SUNDRY NOTICES AND REPORTS ON WELLS (DO NOT USE THIS FORM FOR PROPOSALS TO DRILL OR TO DEEPEN OR PLUG BACK TO A DIFFERENT RESERVOIR. USE "APPLICATION FOR PERMIT" (FORM C-101) FOR SUCH PROPOSALS.) 1. Type of Well: Oil Well <input checked="" type="checkbox"/> Gas Well <input type="checkbox"/> Other <input type="checkbox"/> 2. Name of Operator Cameron Oil & Gas, Inc. 3. Address of Operator P.O. Box 1089, Eunice, NM 88231 4. Well Location Unit Letter <u>C</u> : <u>330</u> feet from the <u>North</u> line and <u>2310</u> feet from the <u>West</u> line Section <u>7</u> Township <u>22-S</u> Range <u>36-E</u> NMPM County <u>Lea</u> 11. Elevation (Show whether DR, RKB, RT, GR, etc.) 3603' G.R.		WELL API NO. 30-025-08820 5. Indicate Type of Lease STATE <input checked="" type="checkbox"/> FEE <input type="checkbox"/> 6. State Oil & Gas Lease No. B015060009 7. Lease Name or Unit Agreement Name State 157 B 8. Well Number 001 9. OGRID Number 181109 10. Pool name or Wildcat [33820] JALMAT; TAN-YATES-7 RVRS

PLUG AND ABANDON PROCEDURE – ORDERED P&A'D BY STATE LAND OFFICE

State 157 B Well No.1

API 30-025-08820

P&A SCHEMATIC - PROPOSED **State 157 B Well No.1**

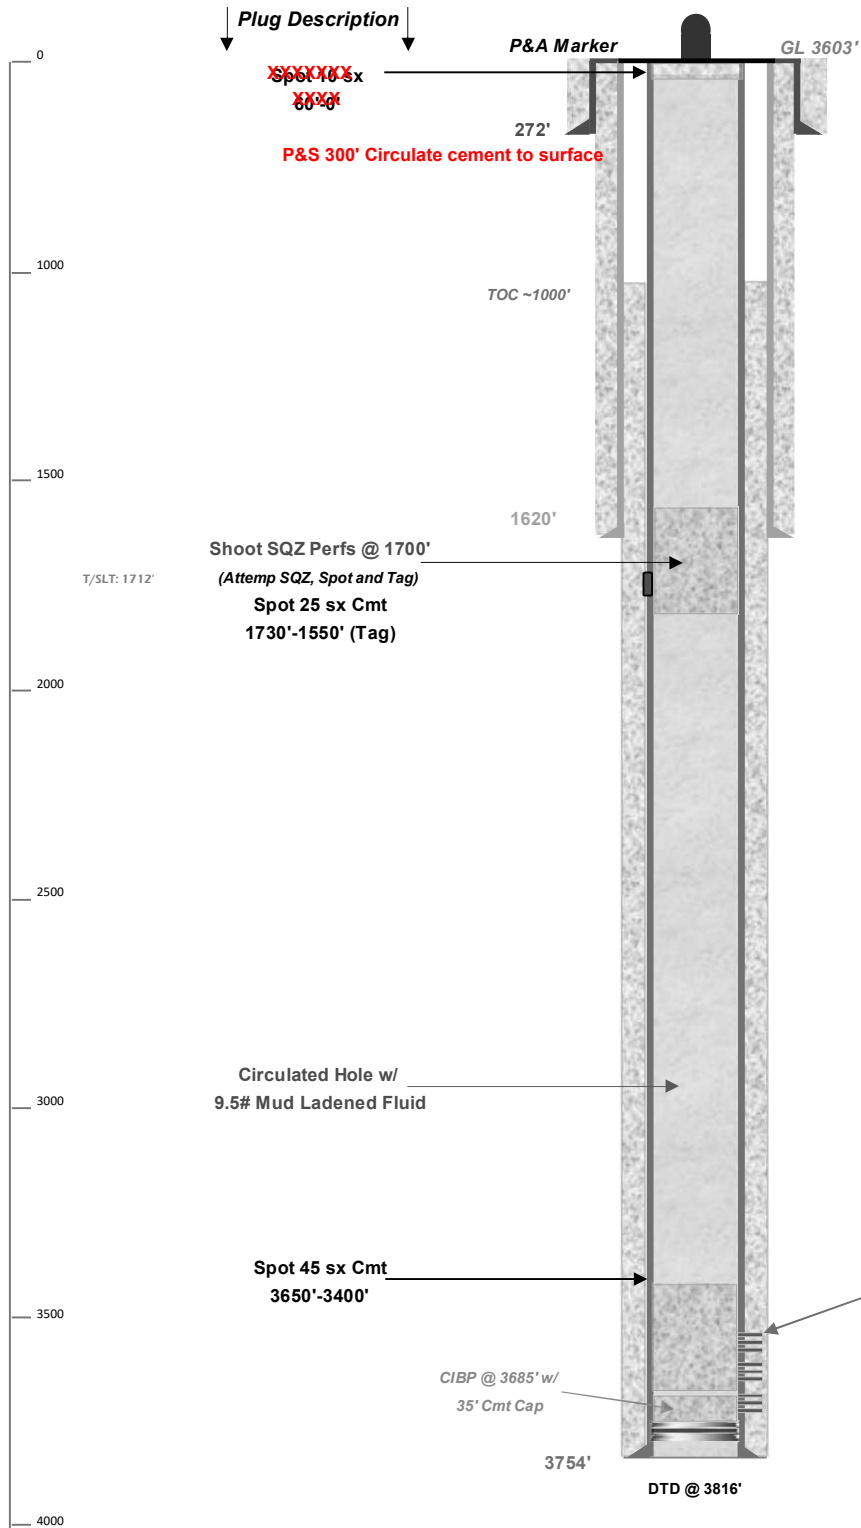
Spot 45 sx 3650 feet to 3400 feet; **WOC & Tag**
 Perf 4 squeeze holes @ 1712 feet (top of salt) – attempt to squeeze, else/ and;
 Spot 25 sx 1730 feet to 1550 feet - TAG;
~~Spot 10 sx 1000 feet to Surface.~~ **P&S 300' Circulate cement to surface**

Created By	Condition	Condition Date
kfortner	See attached Conditions of Approval Note changes to procedure	5/25/2021
